Minimum Transmit Quiet time of EEE 100BASE-TX

Nov 2009
IEEE 802.3az Task Force

Joseph Chou
Realtek Semiconductor Corp.

Figure 24-8 Transmit State Diagram

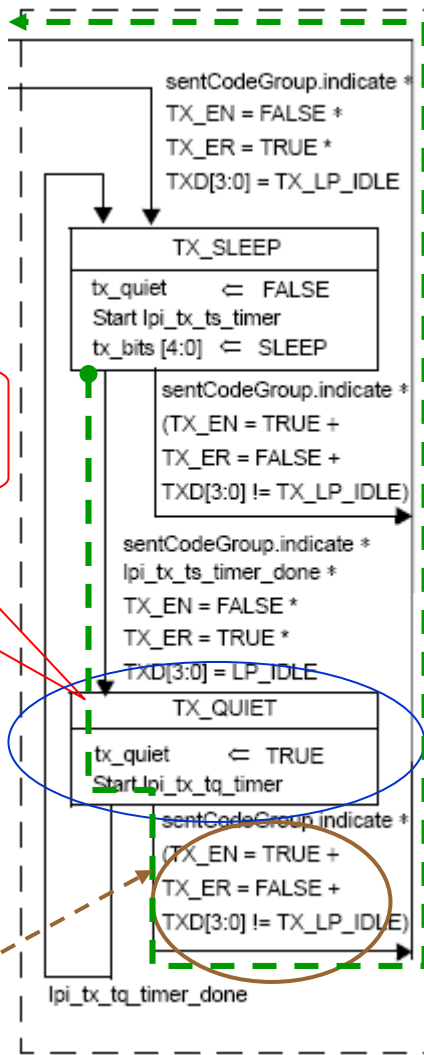
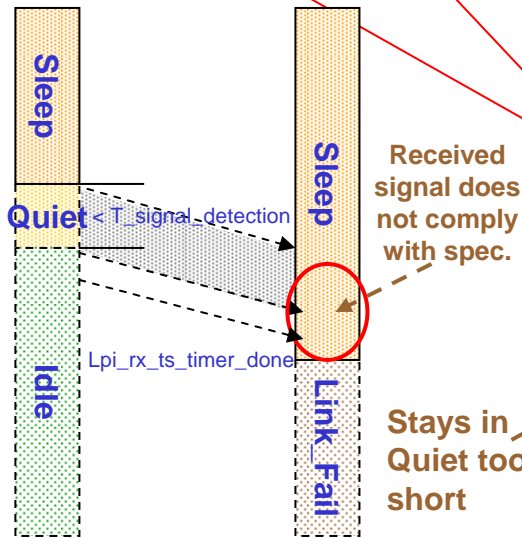
- ❑ In the Transmit State Diagram of Figure 24-8, the TX_QUIET state has a maximum timer `lpi_tx_tq_timer` but lacks a minimum timer.
- ❑ The transmitter may enter the TX_QUIET state briefly and return to the IDLE state anytime when it receives a De-assert LPI from MII.

- ❑ The duration of transmitter staying in the TX_QUIET state may be too short to effectively assert the Signal_detection (5us maximum assertion time) of the receiver at the remote link partner.

- ❑ The transmitter's first 5us symbols after the undetectable short quiet state may not comply with the jitter spec as defined in 25.4.6.
- ❑ The receiver Equalizer (EQ) and Clock Recovery (CR) may lose the track due to the period of "no-signal" or "out-of-spec signal" in the received channel.

- ❑ Finally, the receiver may stay in the RX_SLEEP state unable to decode the symbols correctly, and eventually move to LPI_LINK_FAIL state when the `lpi_rx_ts_timer` is up.

- The Transmitter gets into Quiet state and exits to Idle state too quickly => less than a signal_detection time
- The Receiver continues waiting in Sleep state with a possible messed-up Clock/Data Recovery & Equalizer
- The Receiver finally exits to unintended LPI_Link_Fail state

Suggest a Minimum duration for TX_QUIET state. Implement it with a new $lpi_tx_tm_timer \geq signal_detection\ time$

- ❑ Change the maximum Assert time and De-assert time of Signal_detection of PMD in LPI mode (refer to Table 25-3) to $1 \mu\text{s}$
- ❑ Modify the Transmit State Diagram (Fig 24-8)
 - Add a new timer **lpi_tx_tm_timer** in TX_QUIET state with a value range between $1 \mu\text{s}$ to $1.5 \mu\text{s}$, and start it when entering TX_QUIET state
 - Change the branch condition between TX_QUIET and IDLE from “sentCodeGroup.indicate * (TX_EN = TRUE + TX_ER = FALSE + TXD[3:0] != TX_LP_IDLE)” to “sentCodeGroup.indicate * **lpi_tx_tm_timer_done** * (TX_EN = TRUE + TX_ER = FALSE + TXD[3:0] != TX_LP_IDLE)”
- ❑ Parameters are modified in Table 78-4: Summary of the LPI timing parameters for supported PHYs (numbers in parenthesis are old number)
